CONDITIONS OF APPROVAL:

Engineering - PUD Plan Checklist

Carothers Crossing West PUD Development Plan Initial Submittal 08.13.2018.pdf

40. Stormwater Outfalls

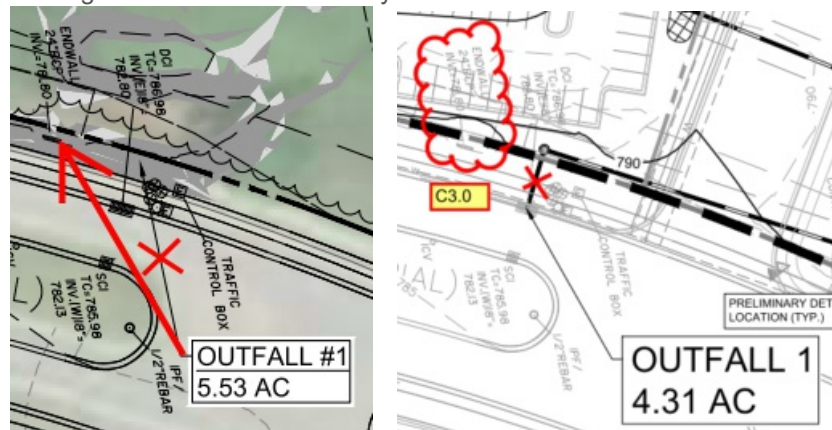
Southeast:

Applicant to revise drawings to reflect the existing outfall along Carothers Parkway clouded below, and modify the area draining to Outfall #2 accordingly.

Northeast:

Applicant to revise the outfall to reference the existing endwall noted below, and not the existing inlet in Carothers Parkway.

41. Stormwater Outfall

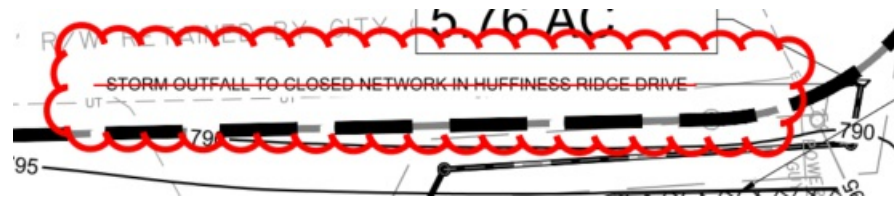
joe.marlo@franklintn.gov Applicant to remove the note clouded below from C3.0. Huffiness Ridge Drive utilizes a ditch section for drainage.

70. G. Grading Plan

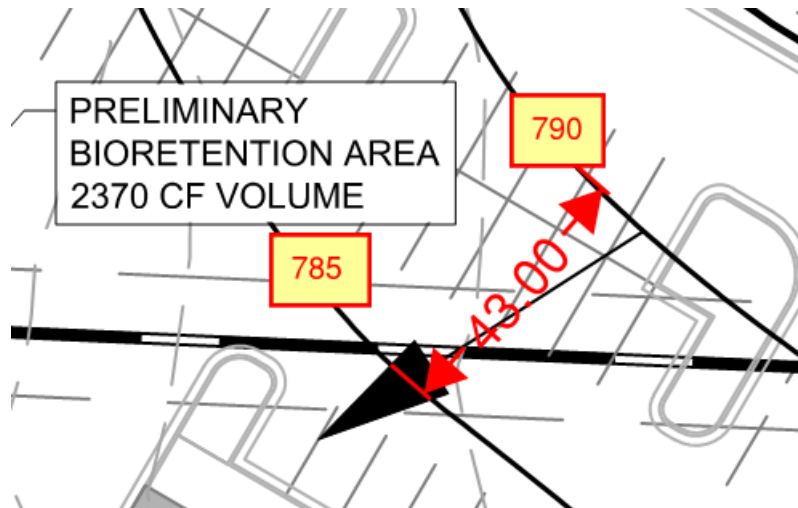
lance.fittro@franklin.tn.gov Applicant shall show all off-street parking areas in compliance with section 5.9.3(10) of the Off-Street Parking Standards of the Franklin Zoning Ordinance:

(10) Maximum Slope

(a) Paved off-street parking areas shall not exceed a six percent slope.

(b) Within off-street parking areas on sloping sites (four percent or greater), parking bays shall run parallel to elevation contours.

The proposed grading plan appears to indicate slopes in excess of 10% in some of the parking areas.

This shall be addressed in detail at the Site Plan stage, but the conceptual grading shown on the Development Plan shall generally comply with these requirements. Failure to address site grading constraints in sufficient detail at Development Plan stage shall not dictate acceptance of slopes or retaining wall heights in excess of those allowed by the Zoning Ordinance at Site Plan stage.

4. Tree Canopy Retention

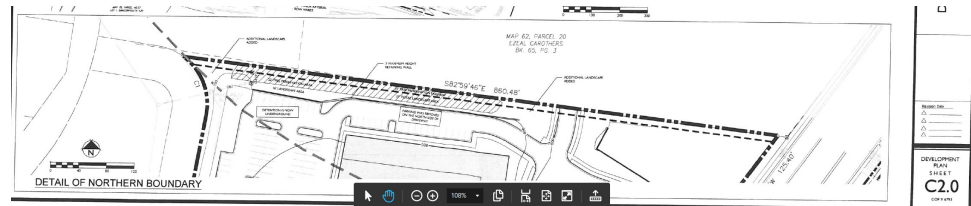
jason.arnold@franklintn.gov In order for DRT to support the applicant's request for payment in-lieu of tree canopy retention, the applicant shall maintain 50% of the required (15%) tree canopy retention.

8. Bioretention

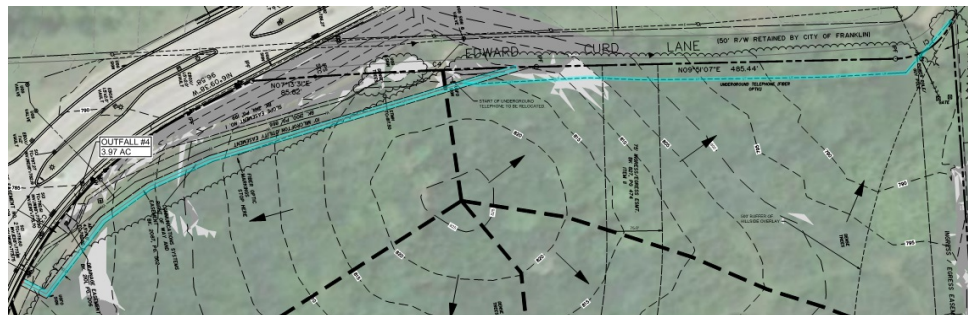
lance.fittro@franklin.tn.gov The existing "underground telephone line" crossing the site that is shown to be relocated appears to be THE critical fiber optic infrastructure owned by AT&T which has been avoided at all costs by previous projects in the vicinity. Applicant shall provide verification that the line will be permitted to be relocated by the utility provider.

Pending this verification, show the line on all plan sheets so that it is clear what the impact to the development will be if it is not permissible to relocate the line as shown on the plans. If it is permissible to relocate the line, it should be relocated such that it does not interfere with the development of the neighboring properties or the roadway that will need to be installed to serve them. **The line shall not be relocated into public ROW as depicted on the current submittal.** Should an inability to relocate the line as shown on the plans necessitate significant changes to the layout of the development, including the external access to the old Edward Curd Lane ROW shown on the plans, the Development Plan must be revised accordingly.
